PUBLIC INTEREST REVIEW FOR GROUNDWATER APPLICATIONS

SUBJECT: Application G- 18303 Supersedes review of 8/24/2016
Date of Review(s)

A. GENERAL INFORMATION: Applicant's Name: R William Lawson Cosseboom County: Jackson

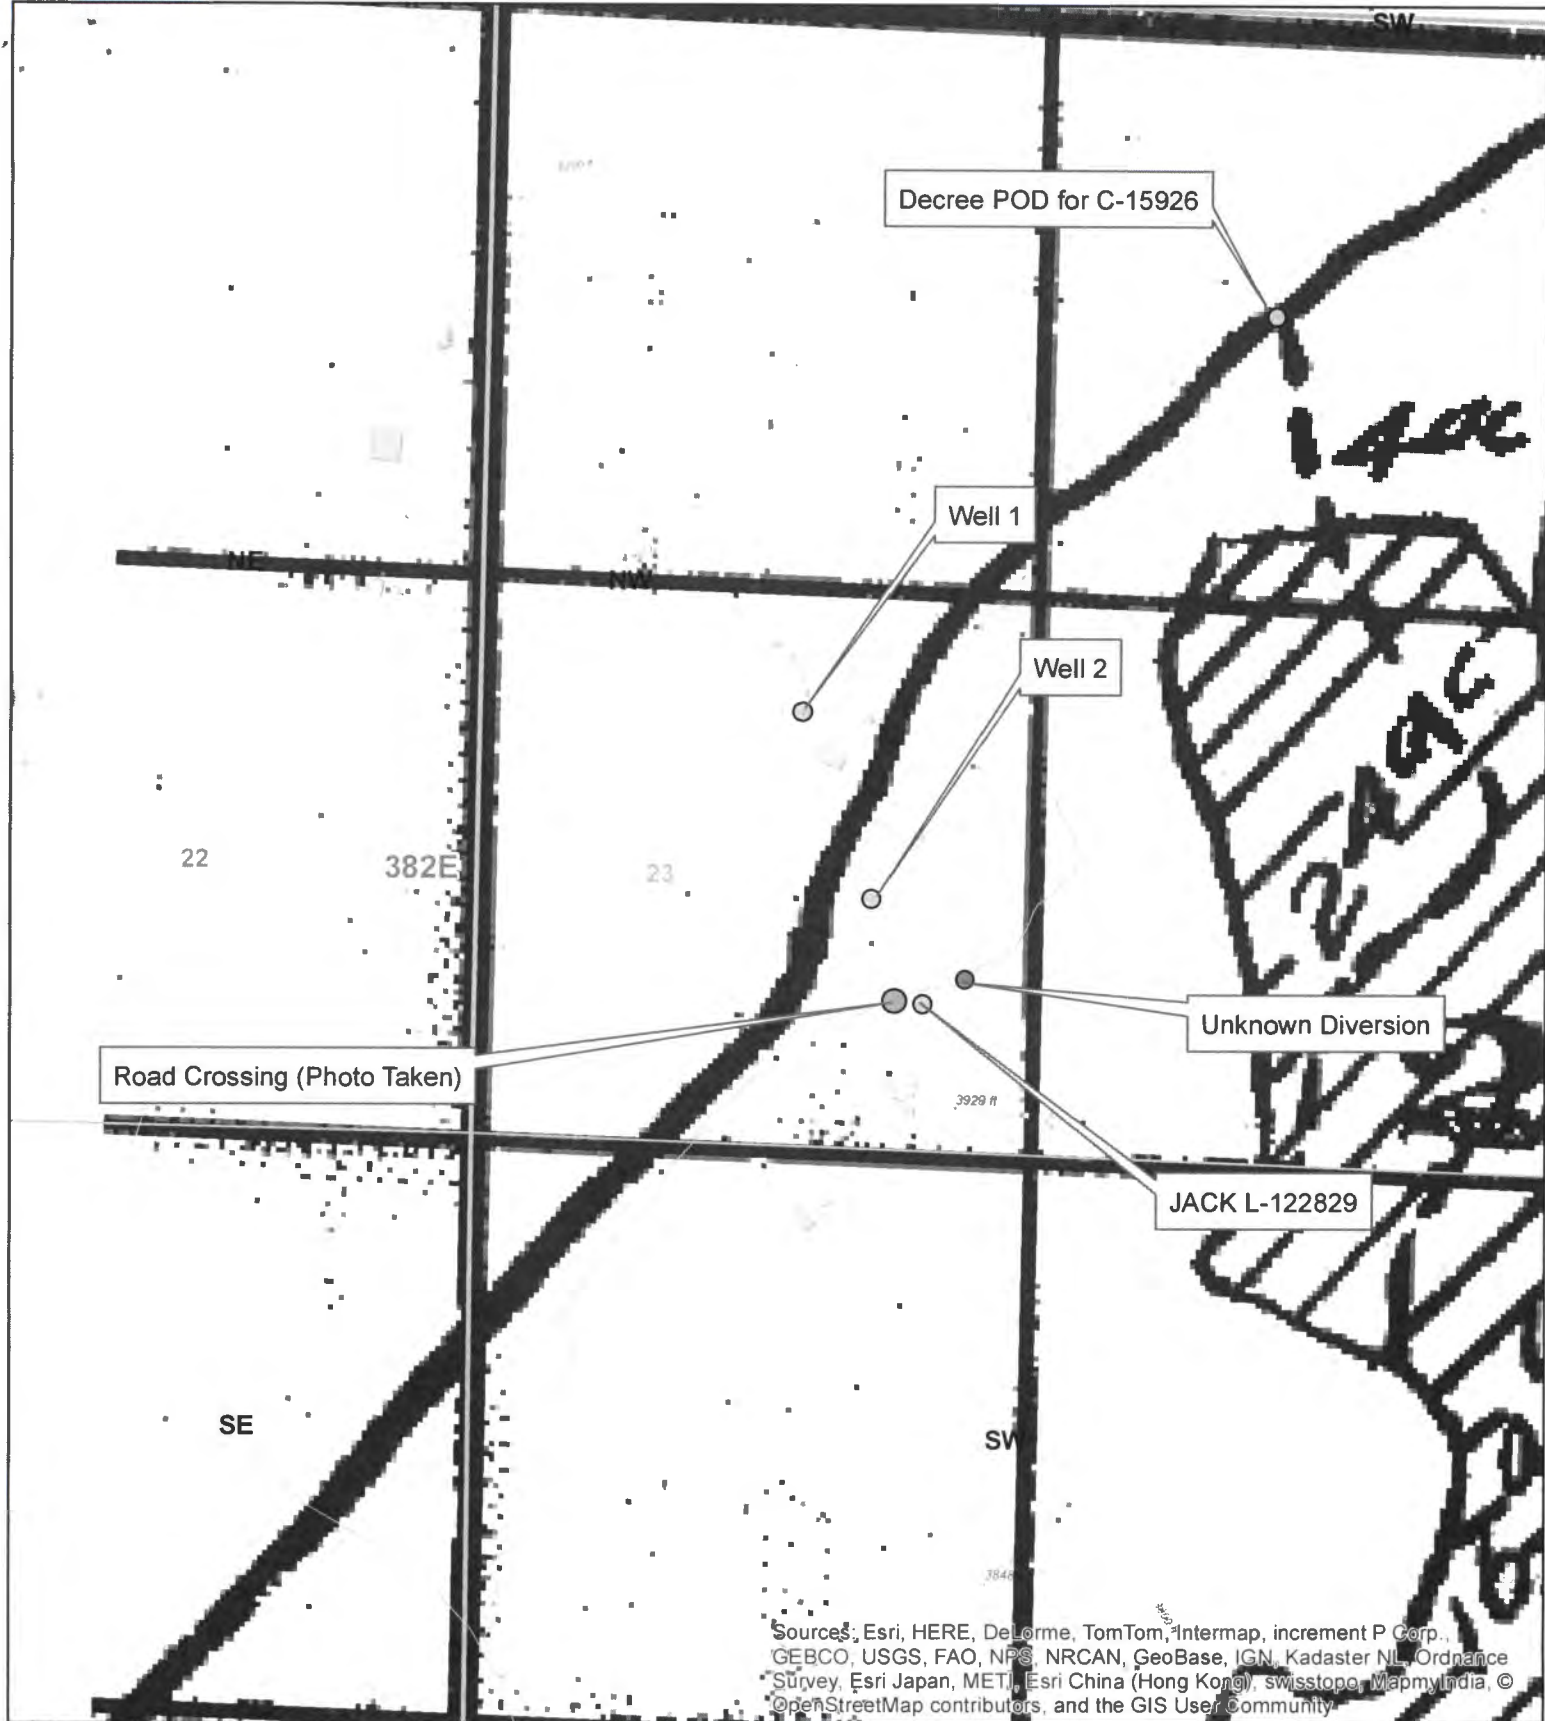
I made a site visit yesterday to G-18303 (see attached map). I was able to stand on a driveway crossing and take photos of the channel (see attached).

During the site visit the channel was dry and lots of vegetation was present. Approx 200 ft US of driveway crossing was an open headgate (see photo). I tried to put much of this on a map to help describe my findings but found it a bit difficult to properly portray. Could you give me a call when you get a chance and we can go over this?

As the applicant relayed to me that the unnamed tributary to Babe Creek near the wells in this application was totally dry during his visit last May and likely all summer, should this intermittent stream even be considered for the 1/4 mile hydraulic connection test?

Basis for aquifer hydraulic connection evaluation: The static groundwater level is above or coincident to nearby surface water, indicating groundwater discharges to surface water and is therefore hydraulically connected. Site inspection by the Jackson County Assistant Watermaster (see attached photos) indicates that the West unnamed tributary to Babe Creek is not a viable surface water source, so evaluation of that tributary is omitted in this analysis.
